# A47 Wansford to Sutton Dualling

**Scheme Number: TR010039**

## **Volume 9** **9.16 Applicant's Response to Written** **Representations**

**9.16 APPLICANT'S RESPONSE TO WRITTEN  
REPRESENTATIONS**

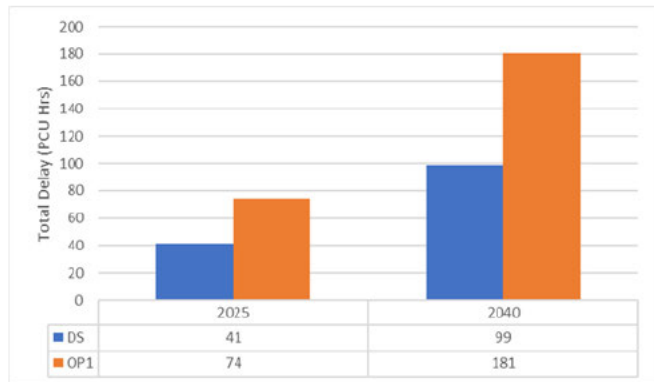
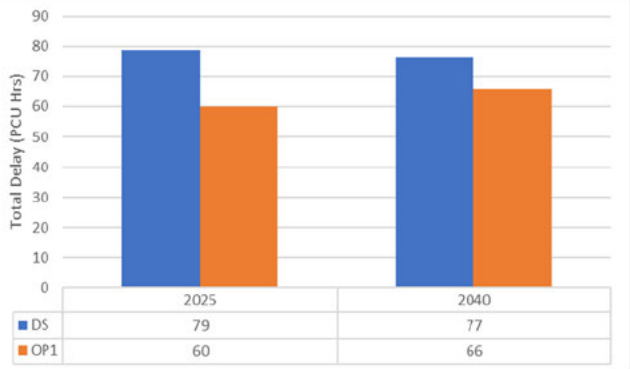
Reference	Written Representation	Applicant's Response																				
	<p>For the traffic on Old North Road Wansford (described by NH as the A6118 even though it was downgraded to be the C340 in 2017) the traffic was shown reducing by 45% and even by 2037, it is still shown as 38% below the 2015 figure. The two way flow in 2015 was 4400 vehicles per day. The projections showed that in 2022 the flow would be 2400 vehicles per day and in 3037 it would be 2700 vehicles per day</p> <p>When they were first released, WPC queried the Old North Road figures and we were told that the reduction was because of the introduction of a 20mph limit in the centre of the village. The 20 mph limit was introduced the 2017 and in autumn 2021 WPC placed a vehicle counting camera on Old North Road. This showed a typical vehicle count of 3900 vehicles per day. At this time, government advice was to work from home as a result of the COVID-19 pandemic. It is not known how much difference that has made but at very least, traffic levels on Old North Road have remained at 2015 levels. They certainly have not reduced by 45%. The detailed vehicle counts from the camera have been given to NH and can be supplied to the Inspectorate if required.</p>	<p>Figure 4-2 shows Old North Road Northbound Traffic. Table 4-2 shows the AADT flow results for Old North Road and the A1 northbound off-slip based on the superseded assessment and Table 4-3 shows the results from the updated results from the TA. The current forecasts reported in the TA represents an opening year of 2025 and a design year of 2040, as opposed to the previous forecasts which represented 2022 and 2037. As it can be seen from this table, the results show that there are smaller differences between the base and the future forecast even though the forecasts represent later years. The reasons for the changes on Old North Road have already been explained above. Table 4-2 and Table 4-3 have also been provided in Annex A for ease of viewing.</p> <div data-bbox="1196 839 2007 1327" data-label="Figure">

Reference	Written Representation	Applicant's Response
		<p>others due to the background growth as well as the re-routing of traffic.</p> <p>Therefore, a two-way AADT flow, which represents an average across 365 days of a year, is not directly comparable to a two-way observed vehicle flow which is specific to specific to a shorter time period (i.e. a one month period, or for weekdays only). The observed data analysis included above, which is based on the AM, IP and PM peak hours and is split by direction is critical.</p>

</div> <p>Figure 4-2: Old North Road Northbound Traffic</p> <p>Table 4-2: AADT results superseded assessment</p>	Time Period	2014	2015	2019	2021	AM	510	450	420	140	IP	130	130	130	130	PM	200	200	190	130
Time Period	2014	2015	2019	2021																		
AM	510	450	420	140																		
IP	130	130	130	130																		
PM	200	200	190	130
